# Team Update 03

# Team Update 02

# Team Update 01

Figure 3-4: The SCALE (Note, cable protectors are shown, but are not part of the SCALE)

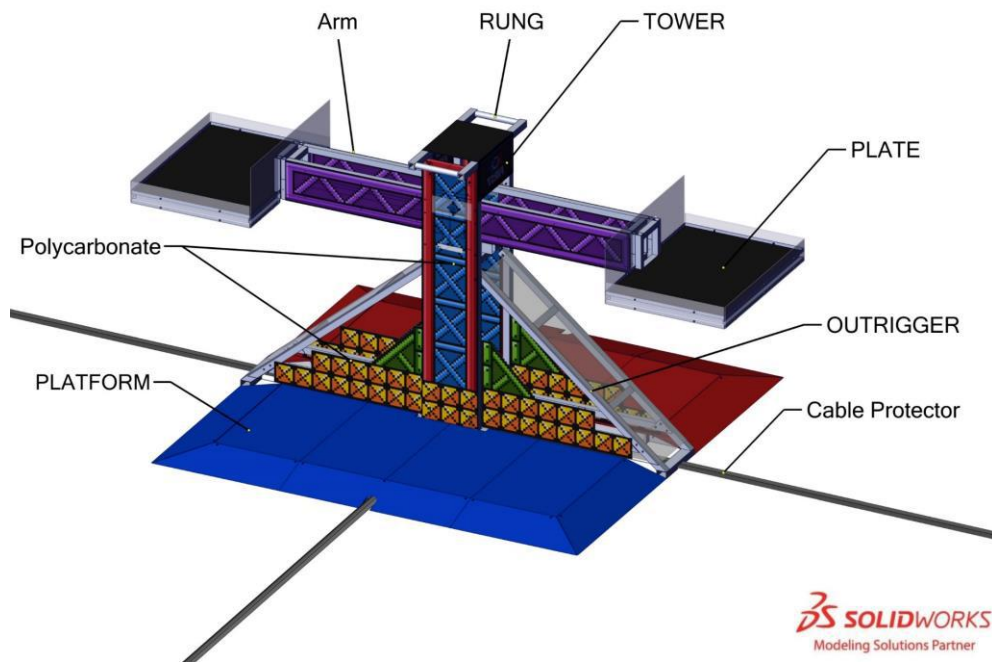
The BRICKS are graphics depicting golden squares surrounded by a black outline that extends 12 in. (~30cm) above the **horizontal** surface of the PLATFORM.

Figure 3-11: PLATFORM top length and width dimensions

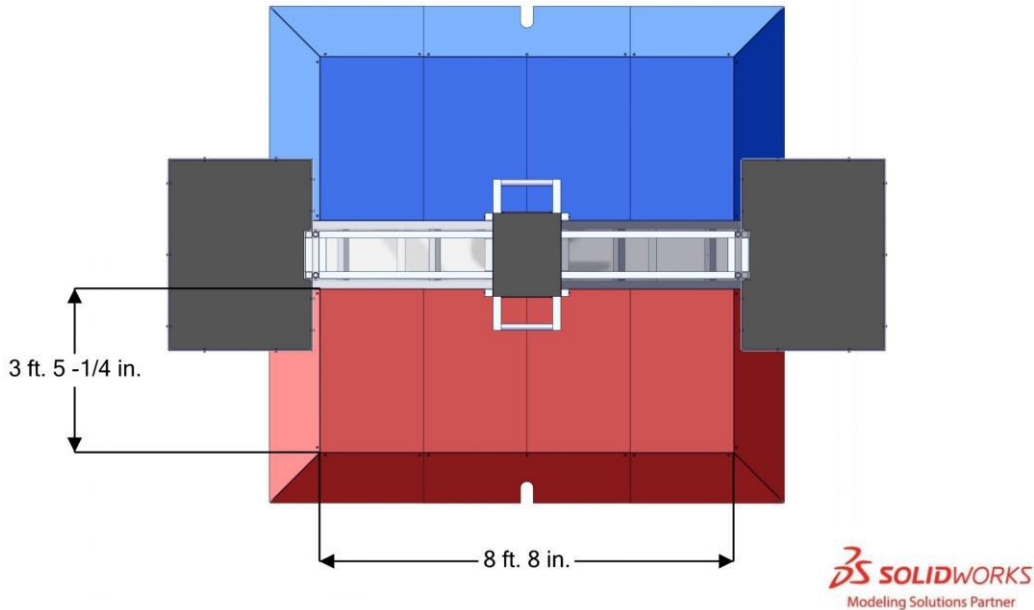
Located at the base of the SCALE, on each side, is a PLATFORM covered with ALLIANCE colored HDPE. The TOWER and OUTRIGGERS separate one PLATFORM from the other. Each PLATFORM top is 8 ft. 8 in. (~264 cm) wide by 3 ft. 5 ¼ in. (~105 cm) deep and 3 ½ in. (~9 cm) tall. The ramps leading to the PLATFORM includes ramps with a run of 1 ft. 4 ¾ in. (~33.32 cm) and long with a 15.35 deg. angle. The ALLIANCE colored tape that abuts the PLATFORM ramps is part of the PLATFORM.

Figure 4-1 Possible PLATE assignments

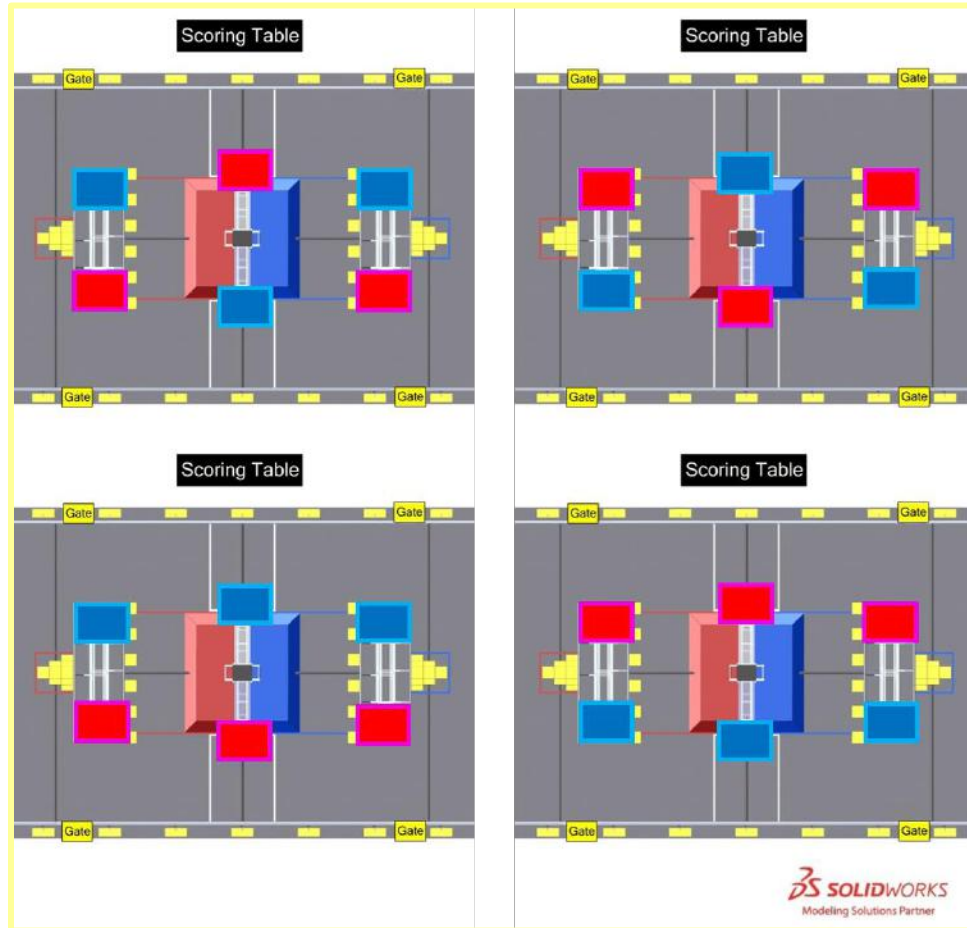
Each MATCH is divided in to two stages. The first stage, called Autonomous (AUTO), is the first fifteen (0:15) seconds of a MATCH in which ROBOTS operate without any DRIVE TEAM control or input. Prior to the start of AUTO, the assignments of ALLIANCE colors for SWITCH and SCALE

PLATES are randomized among the four states in Figure 4-1 and transmitted to the OPERATOR CONSOLE by the Field Management System (FMS). During AUTO, ROBOTS attempt to deliver preloaded POWER CUBES to PLATES, retrieve additional POWER CUBES from around the FIELD, and cross their AUTO LINE any time before the end of the stage.
